Ballarat West DCP Drainage Review

Report on Ballarat West DCP funding review

Figure 1 Current Engeny Drainage Scheme for Precinct 4

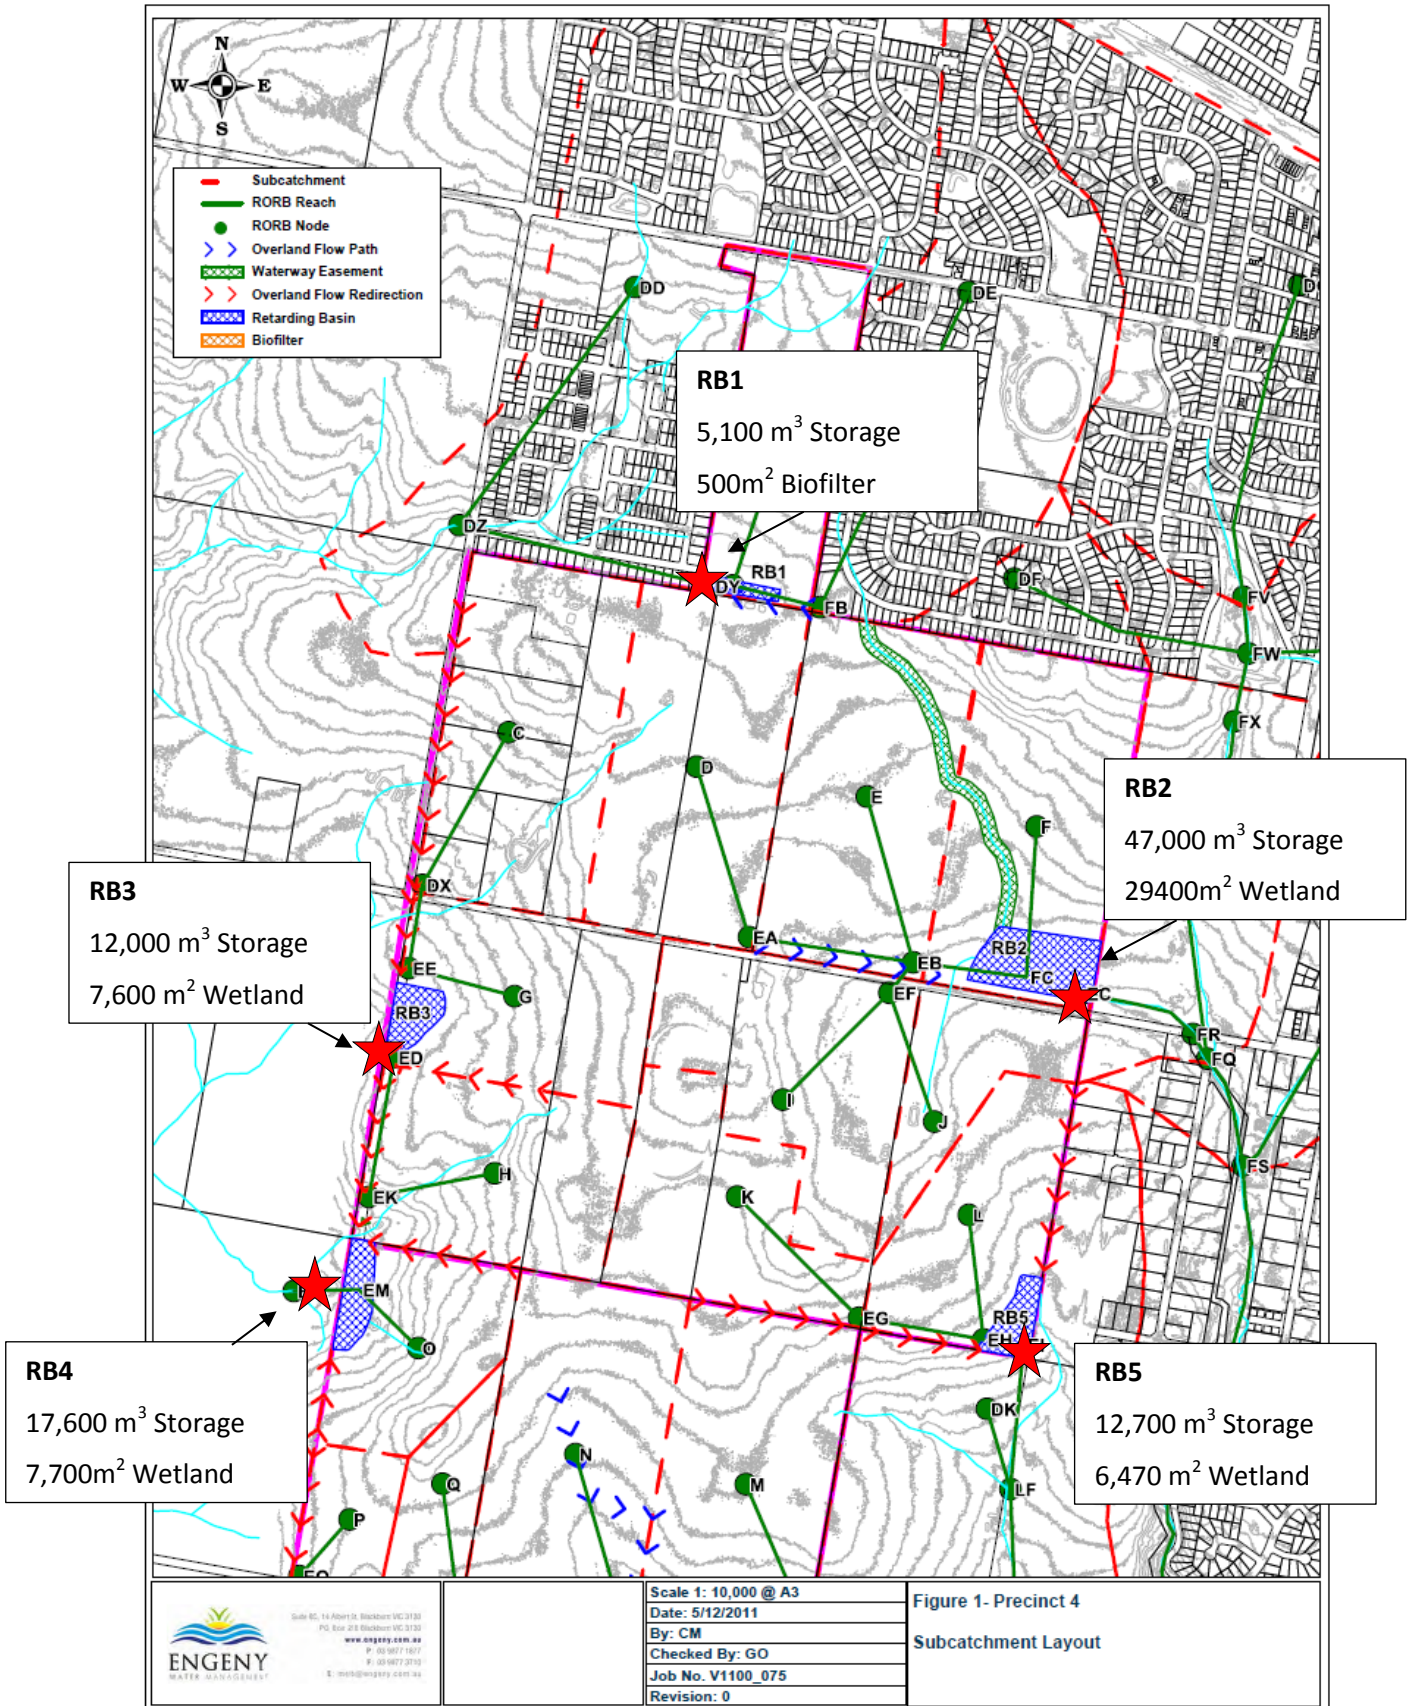
Note that wetland 4 is located within Precinct 2. To contain these works within Precinct 4, a modification of the drainage arrangement at the south-west corner of the Precinct 4 is discussed in Section 8.3 and 8.4.

From a review of the models associated with Precinct 4 it has been found that the precinct meets and in many cases significantly exceeds storm water quality and quantity requirements. It is noted however that there is a small sub-catchment at the south west corner of the precinct that relies on drainage infrastructure within Precinct 2 to meet requirements. This sub-catchment can be easily

Due to the location of RB4 within Precinct 2, a preliminary re-working of the MUSIC model and RORB model has been undertaken to determine the size of infrastructure required to ensure stormwater targets can be met with the Precinct 4 boundaries. Only the south west corner of Precinct 4 has been altered.

RB3 and its associated wetland has been moved to the South West corner of Precinct 4 with sub-catchments H and G now connected to the altered RB/WL. Through an iterative process to meet the best practice target of 45% reduction in Nitrogen, the wetland and associated sediment pond have been sized at 12,000m² and 1500m² respectively.

The RORB model has been re-run with the modification to RB3. The resultant storage requirement to ensure the peak flow is attenuated back to pre-development conditions is 17,200m³. Note this relocation will reduce works in Precinct 2.

Table 3 Precinct 1 and Precinct 2 Water Quality results

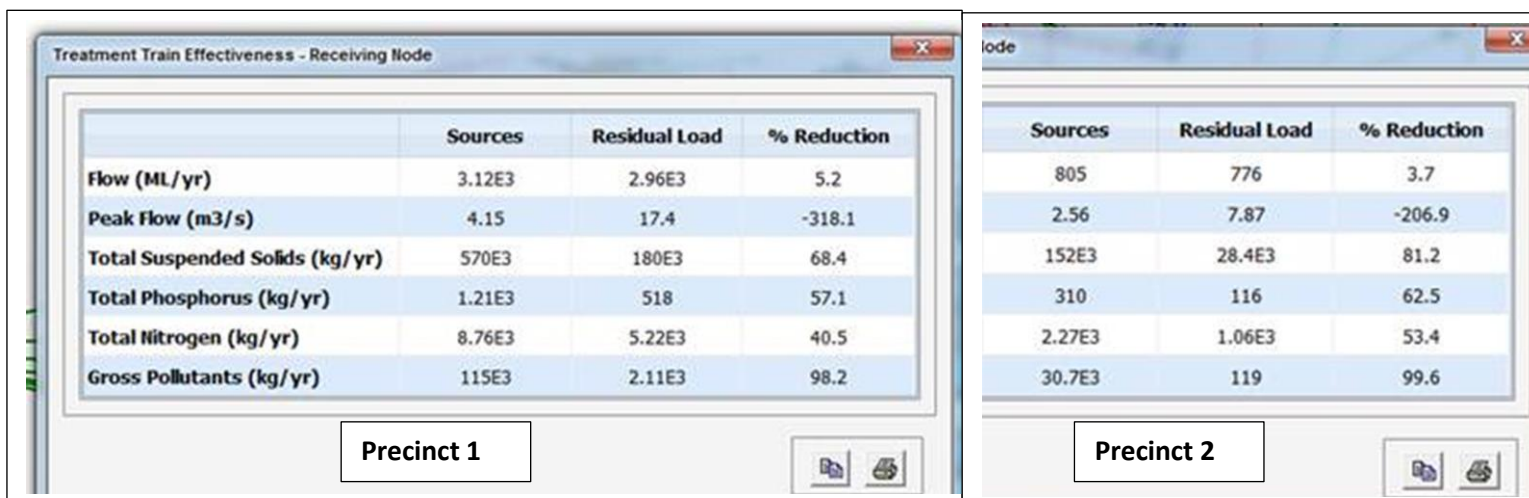
Precincts 1 and Precinct 2 have been checked for compliance with Best Practice requirements at each of their boundaries. As can be seen in the tables below, Precinct 2 meets and exceeds its requirements at the precinct boundary. Precinct 1 is significantly under performing with respect to water quality targets. There is a note in the Engeny report stating that Precinct 1 does meet water quality requirements, though the final numbers are diluted by existing catchments upstream of Precinct 1. This does offer a potential explanation of the numbers below, though this is hard to check. If this is taken at face value, the scheme has been set up to meet water quality targets at each of the precinct boundaries.

Figure 2 Flow comparison points (Engeny, 2012)

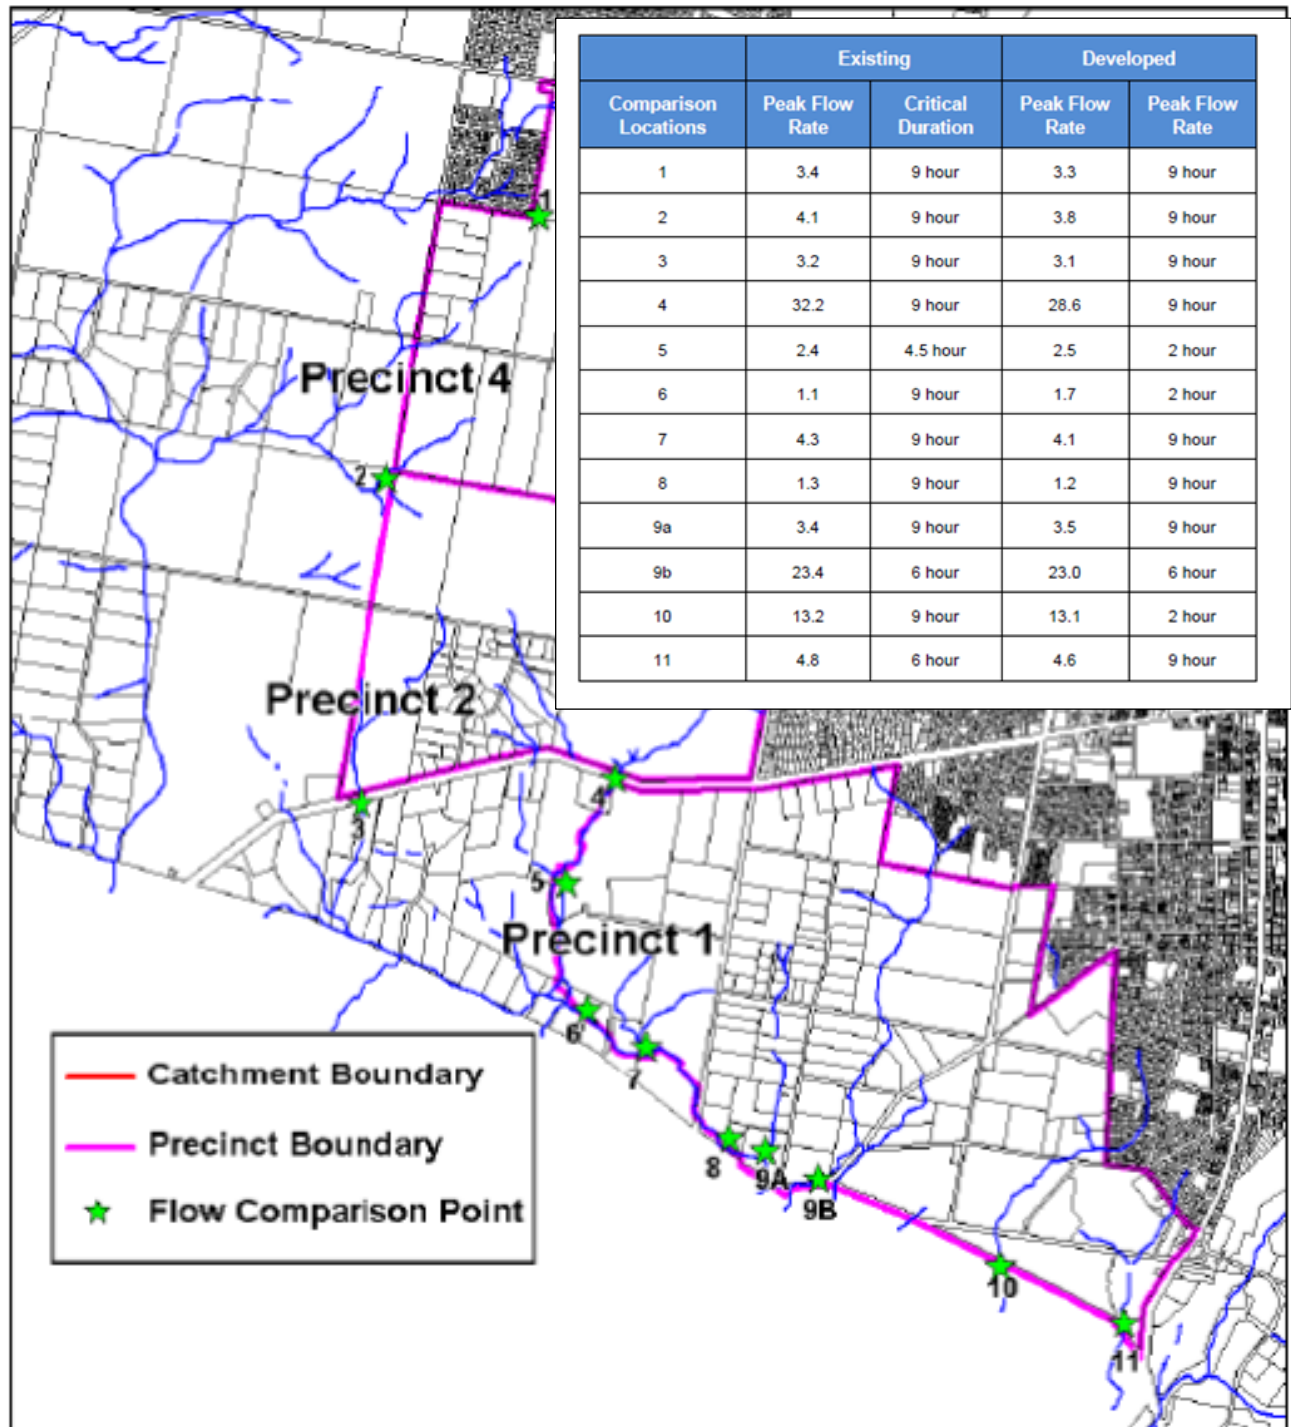
Each Precinct was checked for its hydrological performance at each of the precinct boundaries. In this case the RORB model was not re-run rather the results as reported in the Engeny, 2012 report were reviewed. As can be seen in Figure 2 the flows at all comparison points (typically boundary locations) are less than the pre-developed flow. As such it can be said that each Precinct boundary meets its own water quantity requirements.
